THE GLIDING FEDERATION OF AUSTRALIA

GFA/AD 288

## AIRWORTHINESS DIRECTIVE

Centrair 101, 101A, 101AP, 101P

FIGURE 1

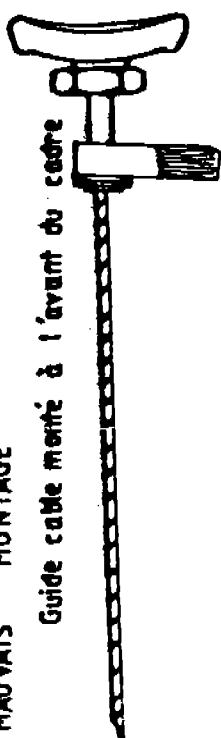
1 - Check whether the cable guiding fittings are mounted in front of the bulkhead (fig.1) or rear of it (fig.2)

2 - If the fittings are mounted in front of the bulkhead, they must be remounted to the rear.
